Brian Limoges

1/15/23

My property: 204 acres between Lexington and Rockdale.

Figure 4-3
Simulated Decline of Potentiometric Surface
in GAM Layer 9 (Simsboro Aquifer)
from Year 2020 to Year 2062 (GAM Run B-3)

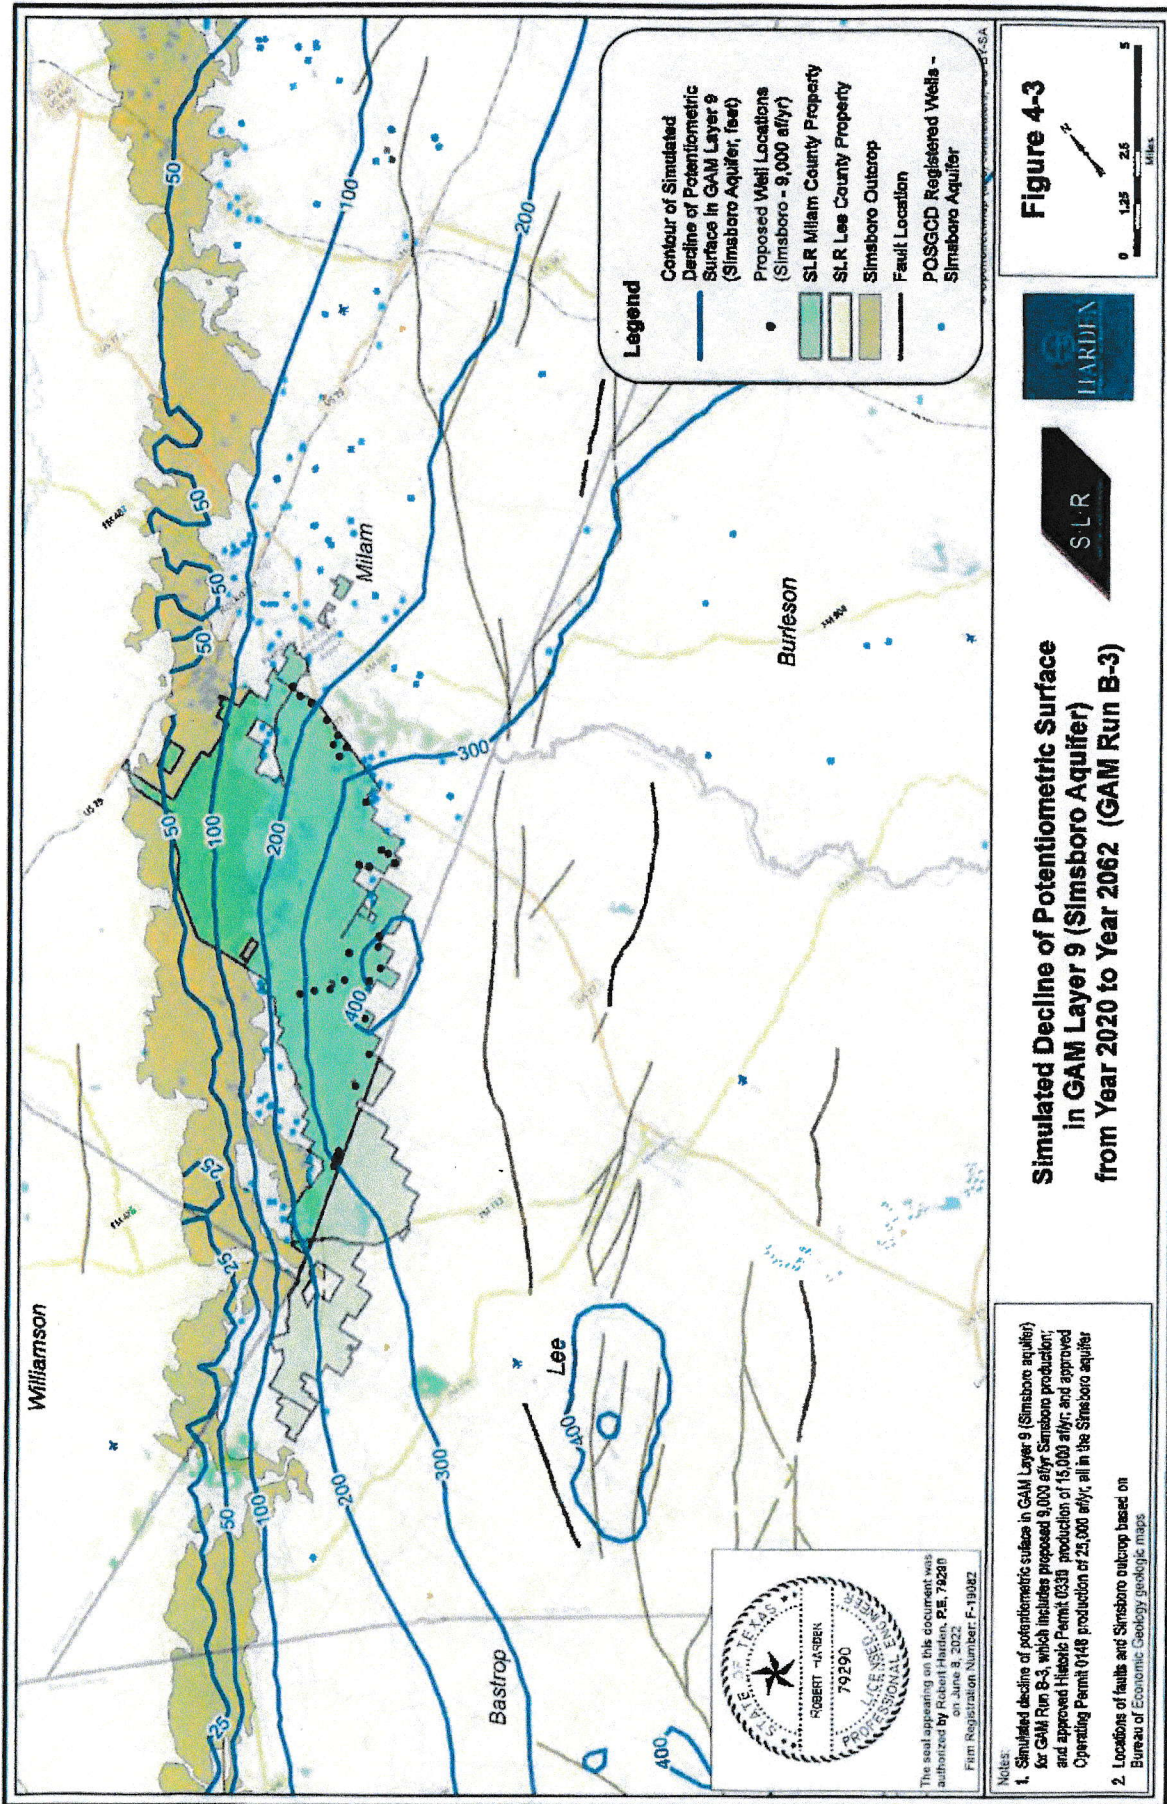
d) – SLR results for drop at my property by 2062 is 400+ (Figure 4.3 – GAM run B-3)

- SLR says my well will drop below the top of the screen in 2050s. Steve' data in 2040s.
- SLR says my well will drop 400+ (from 2020 level). That's 528 foot below the surface.
- If my well is at the top of the Simsboro the aquifer will be completely depressured and will start to be depleted. If it is officially in the bottom of the Calvert Bluff, it seems to be quite well connected to the Simsboro.

Water can also be pulled from the soil layers above and below the Simsboro sands. The soil above the Simsboro separates it from the poorly formed Calvert Bluff aquifer. The Simsboro is forecast to drop 400 feet of pressure at my property. The Calvert Bluff aquifer formation water level (pressure) is forecast to drop 50-100 feet on my property (figure 4-5). This seems to be due to something in the east (bigger drops east). **The difference in pressure between the Simsboro and the Calvert Bluff aquifers will increase the driving force for water to move from Calvert Bluff into the Simsboro.**

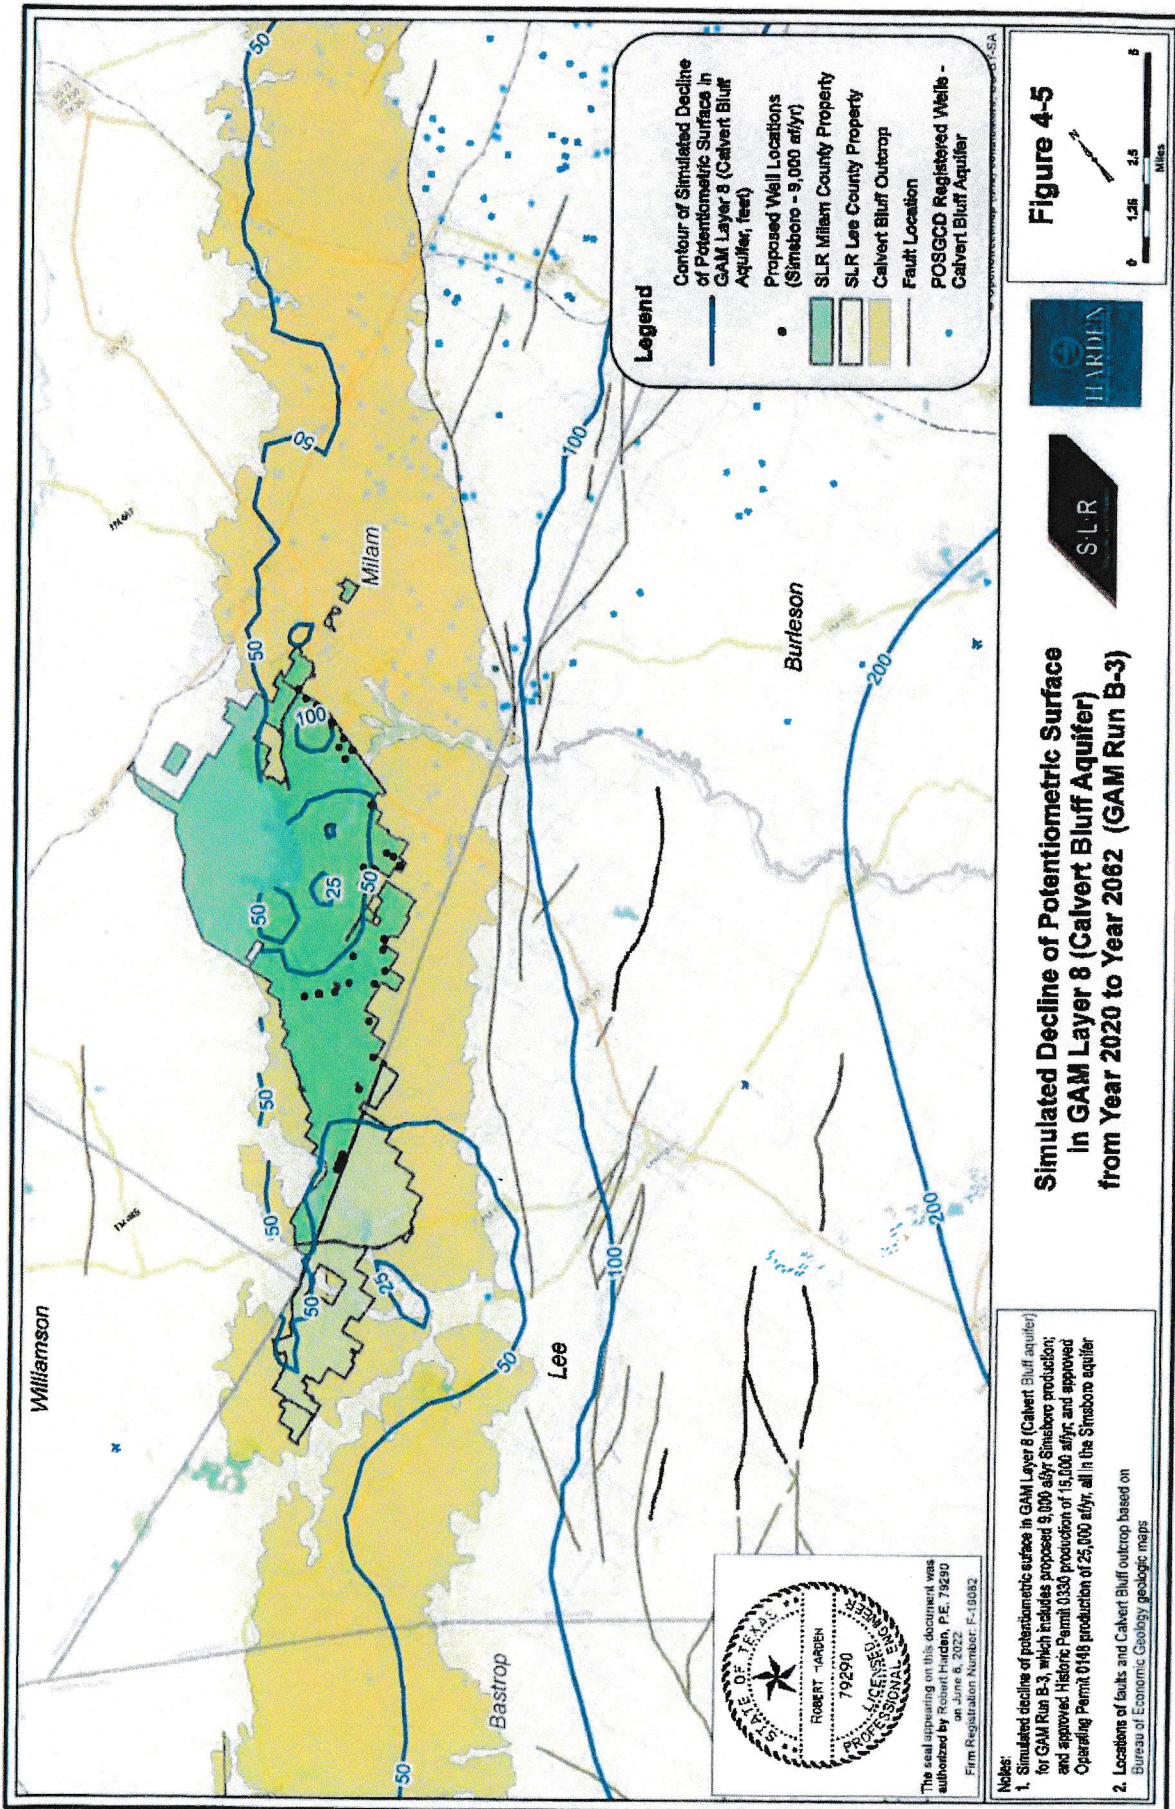
Figure 4.6 shows Simulated Decline of Potentiometric Surface in GAM layer 2 for Carrizo-Wilcox Outcrop. The decline is 50+ feet on my property and surrounding area. **This is NOT coming from the east. Rather seems to be a result of these permits.**

I think this says that a 50-foot drop in the "confined" part of Calvert Bluff will result in a 50-foot drop in the ground water at the outcrop (minus pressure drop - if pumping). I also read that for a nice "clean" aquifer, the outcrop ground water level is often used to determine the condition of the aquifer.
